## **PROJECT DESIGN CHANGE SUMMARY REPORT**

**BORNISH WIND ENERGY CENTRE**

**JULY 2012**

Client	NextEra Energy Canada, ULC
Contact	CONTACT
Document No.	1008-CAMO-R-08
Issue	B
Status	Final
Classification	Client's Discretion
Date	19 July 2012

**Figure 3-1: Design Change 1**

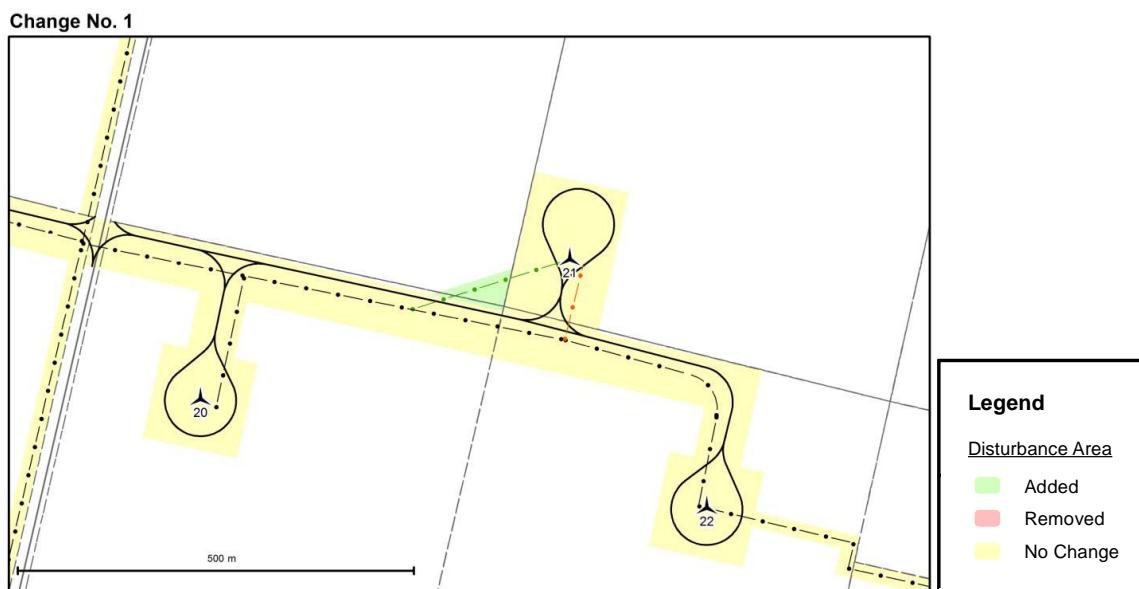
The revised collector cable routing for Turbine 21 runs approximately 215 m east of the intersection of the collection line for Turbine 20, at this point the collection line is proposed to run diagonally northeast to connect to Turbine 21. The original design proposed the collection line to run approximately 415 m east of the intersection then north to Turbine 21 and will be removed from the optimized layout.

Pursuant to consultation with the construction team the underground collection cabling for Turbine 21 has been re-configured to reduce the length of cable required to connect Turbine 21 to the Project. This change has resulted in an approximate 88 m reduction in the length of collection cable required to connect Turbine 21 to the Project.
